**Final Site Investigation Report
Remedial Action Plan
Boise Towne Square Mall
Boise, Idaho**

**Final Site Investigation Report/
Remedial Action Plan
Boise Towne Square Mall
Boise, Idaho**

**DEPARTMENT AND CITY COMMENTS AND
RESPONSE TO COMMENTS LETTERS**

Re: Review of Draft Site Investigation Report/Remedial Action Plan (SI/RAP) Boise
Towne Square Mall Boise, Idaho

SUMMARY OF PCE ANALYTICAL RESULTS AND GROUNDWATER
CONCENTRATION CONTOURS. DATE 1995.

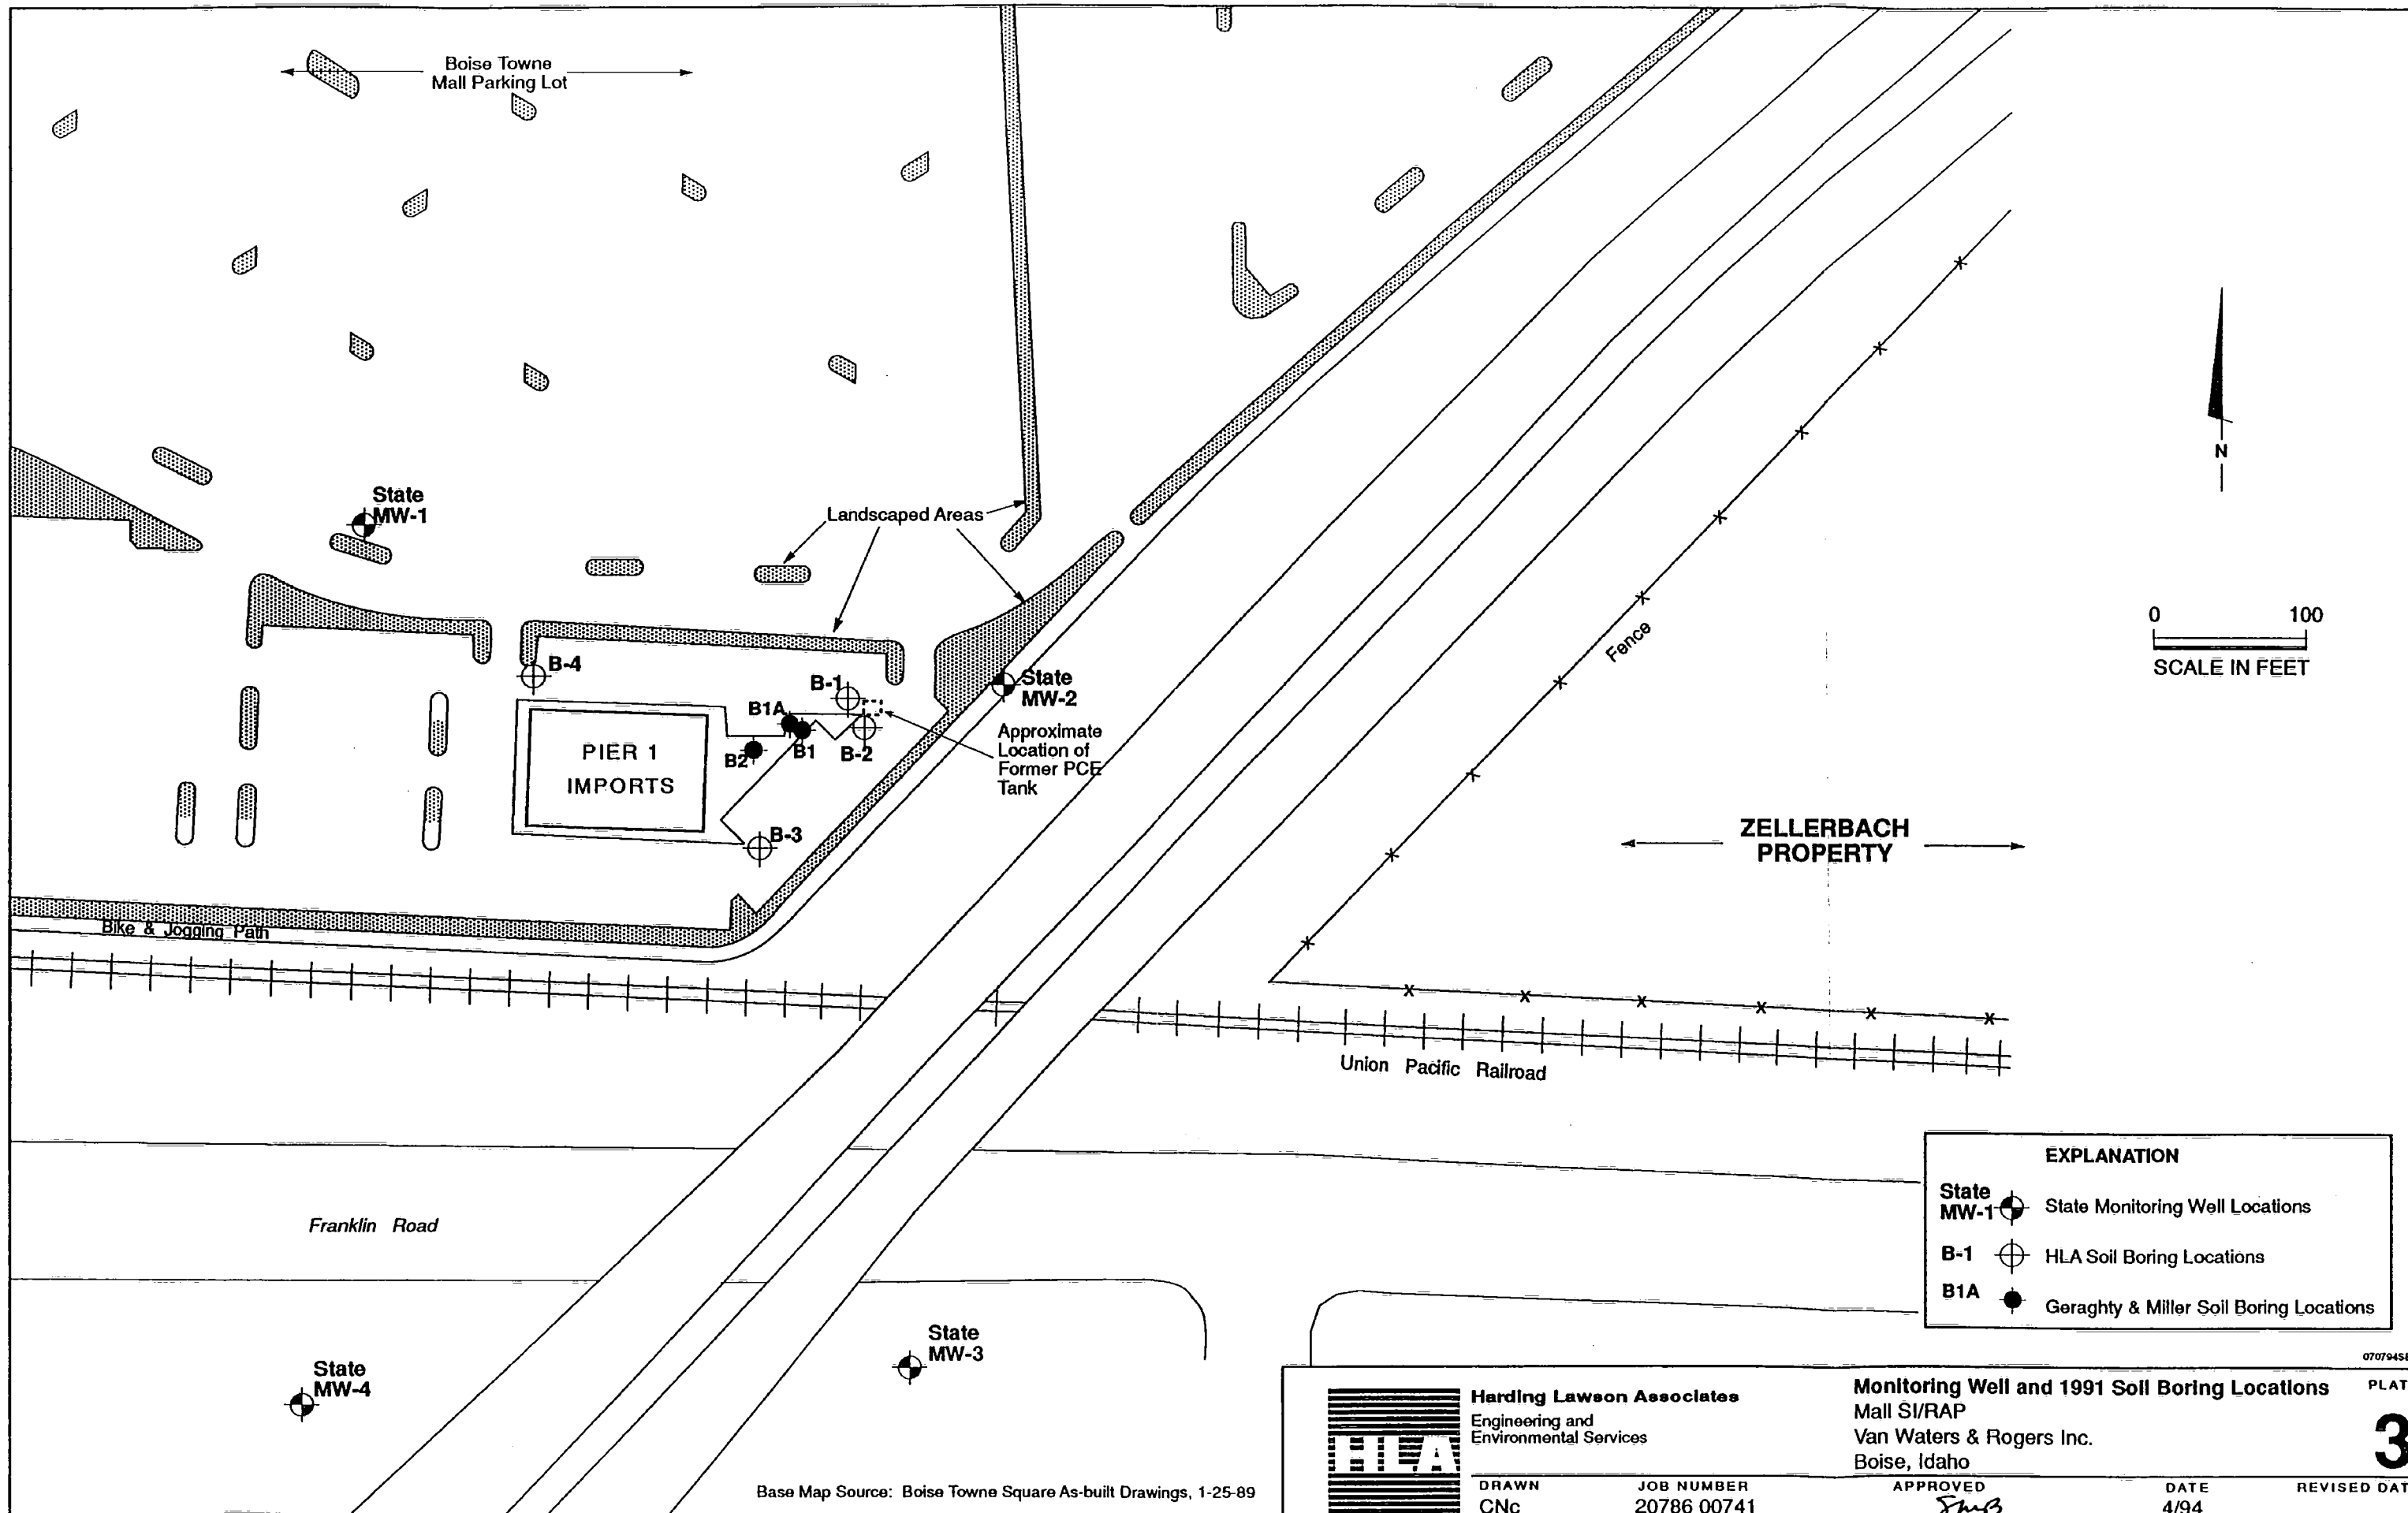
Comment 16: Plate 2: This plate is extremely hard to interpret. Sampling locations are hard to locate and contaminant concentrations are hard to identify. In some cases, contaminant concentrations can not be read at all (e.g. GZ-6 and VW& MW-1). It would be extremely helpful to the reader if unnecessary information was removed from the plate (such as the parking lot row configuration lines and traffic direction arrows, etc. . .). Furthermore, infrastructural information (such as building etc. . .) could be screened during the printing process so as to appear as background information. This would highlight sampling locations and analytical data. Information provided should include borehole and monitoring well total depths. Explanation is also not provided as to why some sampling locations have more than one contaminant concentration. Please provide explanation.

Comment 17: Plate 2: This plate should be oriented consistently with the other plates within the report.

Comment 18: Plate 2: The lack of data within the highest contaminant contour interval near the northwest site boundary leads the reader to conclude that this contour was conveniently closed at the site boundary. Unless there are data to support this closure, it should remain open in the downgradient direction as do the other contours.

Comment 19: Plate 2: It is evident that there are limited data defining the lateral extent of the contaminant plume. These data gaps are most notable on the northeast site of the plume near the mall structures, on the southwest side near the theater, and near the site boundary. There also appears to be a lack of ground water control on the lateral and vertical extent of the contaminant plume. Additional ground water data in the lateral direction and along the northwest site boundary would strengthen the delineation of the contaminant plume.

Comment 20: Plate 2: The contaminant levels near the northwest site boundary appear to lend support to the necessity of continuing the investigation offsite. . . .

Response: Seismic reflection profiles are recorded on long, narrow strips of paper and would be technically difficult to include in the report. The profiles are available for review upon request. The locations of the seismic reflection profiles will be added to Plate 2.
